**From:** [Conservation & Design](#)  
**To:** PF/20/1564 - Burlington Hotel, Sheringham  
**Cc:** 08 January 2021 09:30:34  
**Subject:**  
**Date:**

**From:** Chris Young <[\\_\\_\\_\\_\\_](#)>  
**Sent:** 02 February 2021 08:59  
**To:** Jo Medler <[\\_\\_\\_\\_\\_](#)>  
**Subject:** PF/20/1564 - Burlington Hotel, Sheringham

**From:** Chris Young  
**Sent:** 17 February 2021 17:01  
**To:** Phillip Rowson  
**Cc:** Jo Medler  
**Subject:** PF/20/1564 - Burlington Hotel, Sheringham

#### North Elevation

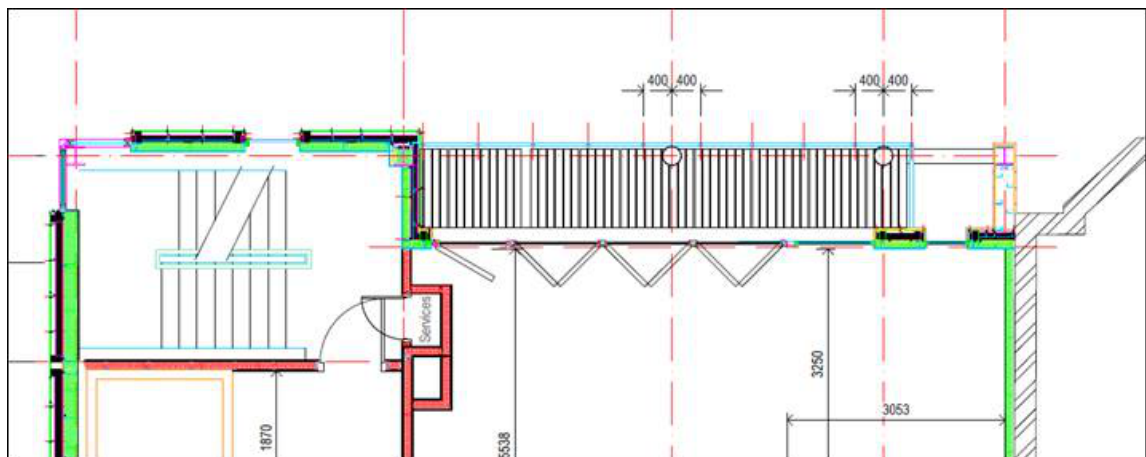
- Similarly, the extension as approved made allowances for the decorative cornice which returns around the west gable under a small tiled roof. This was in recognition of the

importance of this feature in capping both the main elevation and the east-facing return (in which a similar detail can be seen). The second photo above shows this feature more clearly prior to its apparent removal.

As proposed, however, it would appear that this has been unceremoniously chopped off so that the steelwork can be driven past and out to meet the new corner post (see yellow circle in the image above). This alteration therefore has to be considered insensitive and harmful.

### West Elevation

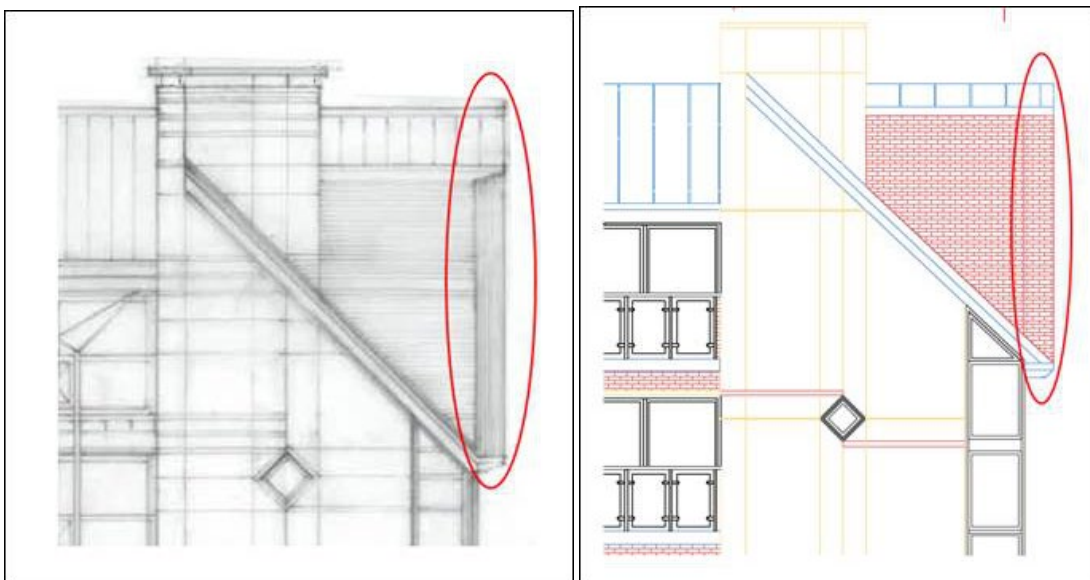
- As approved, the transition from the lift/stair tower to the accommodation was marked not only by a change of facing material but also by a change in the plane of the elevation. Not only did this reinforce the junction between the north and west-facing gables but it also added depth and interest to the elevation.

As proposed, however, this step would be removed and the two materials would be left to just run into each other with a flush butt joint. The net result would remove this important articulation and thus leave us with a comparatively flat and heavy looking elevation. It would also remove the ability to complete the feathered eaves line on the lift/stair tower.

- As approved, the west-facing gable featured a main pitch which appeared to match that of the main building. As a result, it had a degree of compatibility and an upright proportion which would have helped to draw the eye away from the overall scale and massing. It also featured a deep overhanging verge which would have provided a useful shadow line and visual cap.

As proposed, however, the pitch of the roof has been slackened off to allow for the jacking up of the eaves at the back of the new build – the consequence would be a weightier and less elegant looking gable. It would also seemingly no longer have the overhanging verge detail (at least from what we can infer from the northern elevation – see before and after extracts below). Instead the indication is that it would only be capped with a less effective fascia board (unless the brick slip hatching has been wrongly applied).

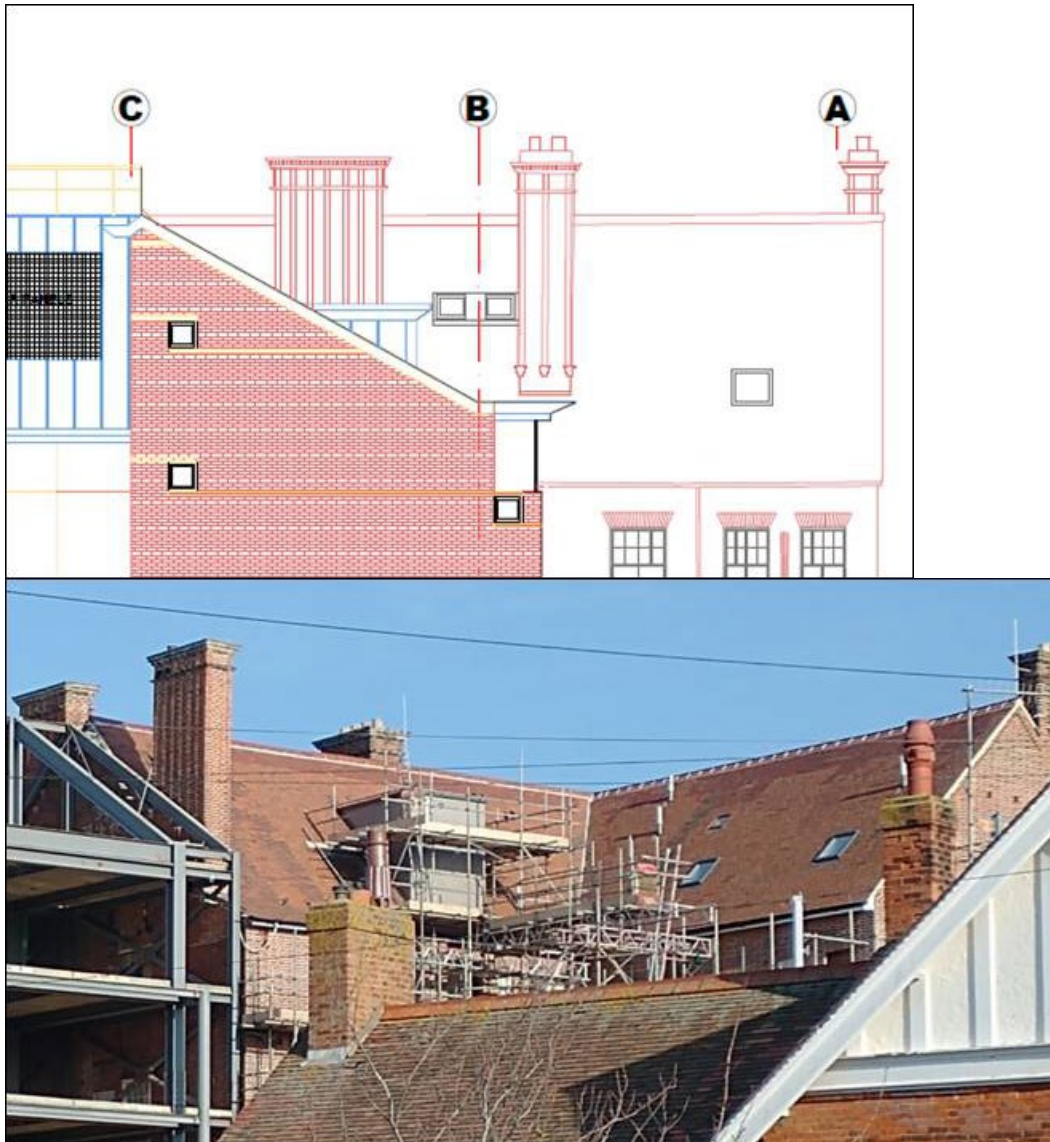
- On another point of detail, this elevation shows two large chimneystacks on the existing

building. However, only that on the gable end still appears to be in situ. Whether the applicants have knocked the other one down is unclear. The configuration of rooflights on the existing building also appears to be innaccurate (see images below).

### North Elevation

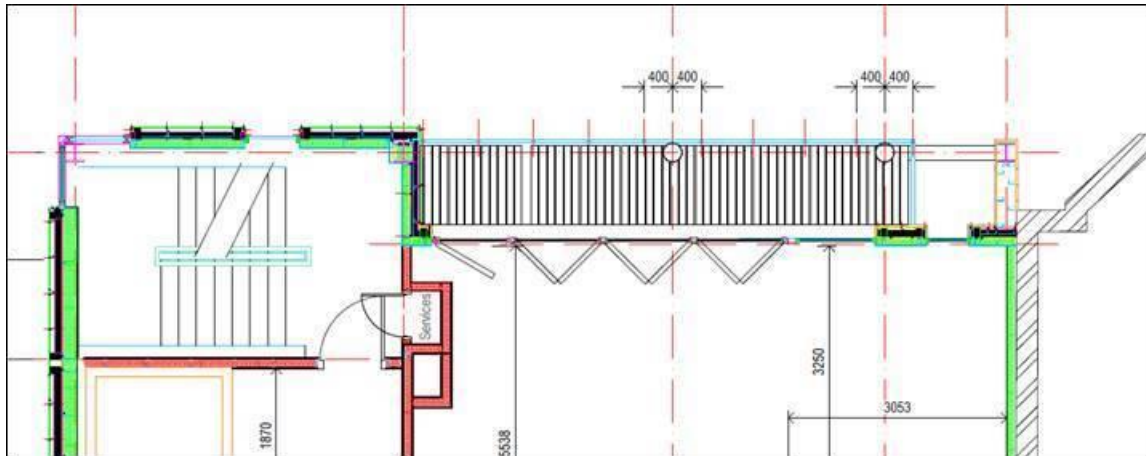
- Similarly, the extension as approved made allowances for the decorative cornice which returns around the west gable under a small tiled roof. This was in recognition of the importance of this feature in capping both the main elevation and the east-facing return (in which a similar detail can be seen). The second photo above shows this feature more clearly prior to its apparent removal.

As proposed, however, it would appear that this has been unceremoniously chopped off so that the steelwork can be driven past and out to meet the new corner post (see yellow circle in the image above). This alteration therefore has to be considered insensitive and harmful.

The latest information confirms that this eaves and cornice detail would be retained. Whilst on the face of it this is something that we should be able to welcome, there are two reasons why support cannot nicely be offered at the time of writing; i) it has already been removed and therefore cannot be retained – it would have to be reinstated, and ii) the actual act of reinstatement would surely be impeded by the return steelwork and the diagonal bracing. Even if it can physically be put back, it would be set in behind the corner post and would therefore lose some of its impact.

### West Elevation

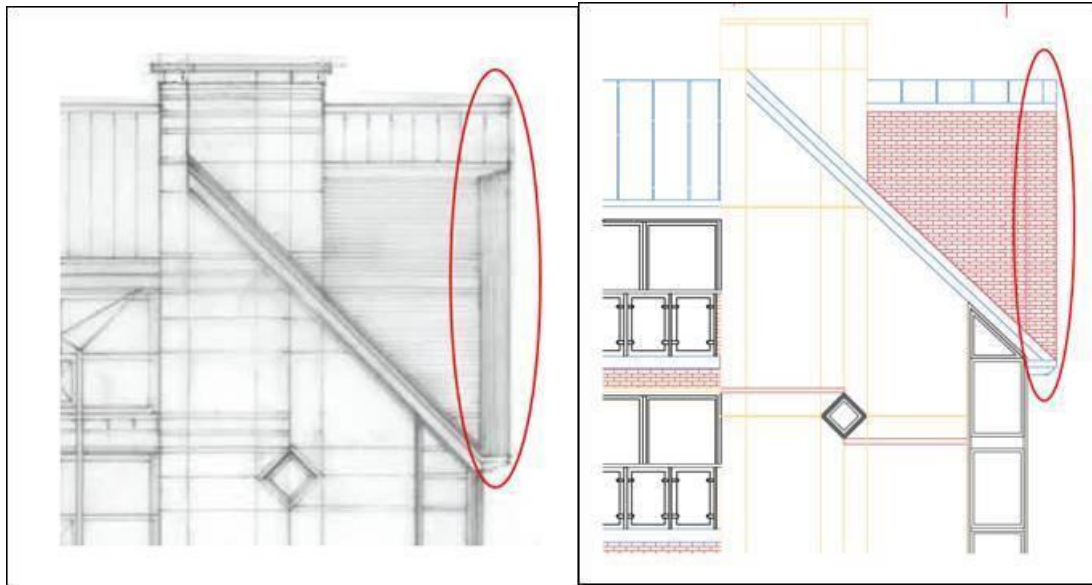
- As approved, the transition from the lift/stair tower to the accommodation was marked not only by a change of facing material but also by a change in the plane of the elevation. Not only did this reinforce the junction between the north and west-facing gables but it also added depth and interest to the elevation.

As proposed, however, this step would be removed and the two materials would be left to just run into each other with a flush butt joint. The net result would remove this important articulation and thus leave us with a comparatively flat and heavy looking elevation. It would also remove the ability to complete the feathered eaves line on the lift/stair tower.

The amended plans show the Trespa cladding being pulled 200mm out from the face of the brick slips. Whilst it is not clear how this would be done in practice (presumably some kind of projecting form/stud work), this is not critical from a planning point of view. More relevant is the fact that it would reinstate some much needed relief and a shadow line between the two materials. It therefore must be regarded as a positive move.

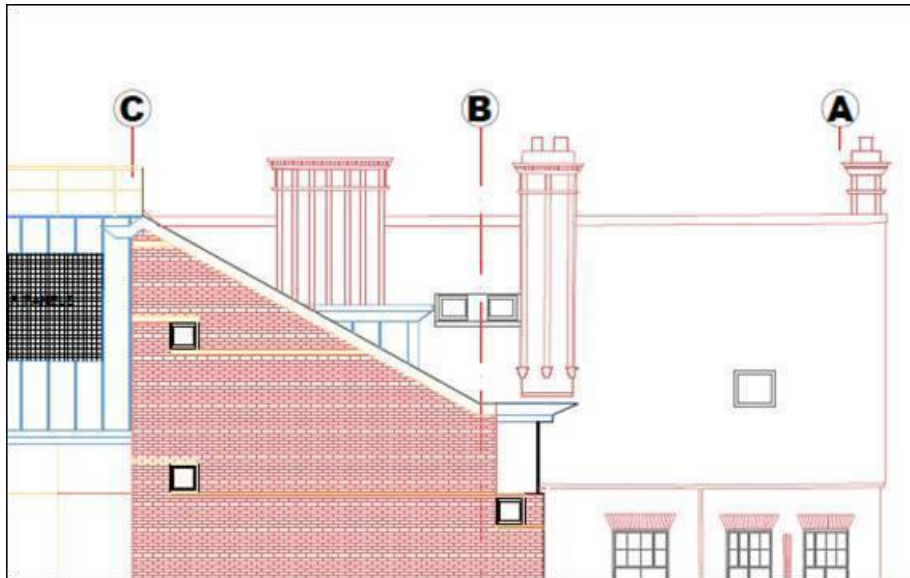
- On another point of detail, this elevation shows two large chimneystacks on the existing building. However, only that on the gable end still appears to be in situ. Whether the applicants have knocked the other one down is unclear. The configuration of rooflights on the existing building also appears to be inaccurate (see images below).  
The configuration of rooflights has now been corrected but the absence of the second chimney on the proposed elevation appears to confirm that this has been taken down. Harm has therefore resulted from the loss of this important secondary stack.

**2. The new build would represent a less refined/elegant version of that approved.**

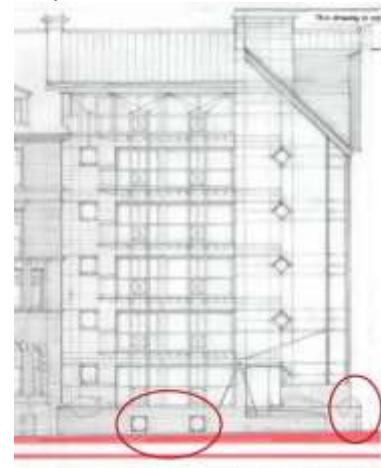
Particularly on the front elevation the extension would affectively 'lead' with its steelwork visually. Even if sections of this would be sheathed with curved aluminium profiles, the end result would still surely be a comparatively crude re-enactment of the original scheme. As approved, the skeleton would have remained silent and the balconies would have cantilevered gracefully out of the main elevation.
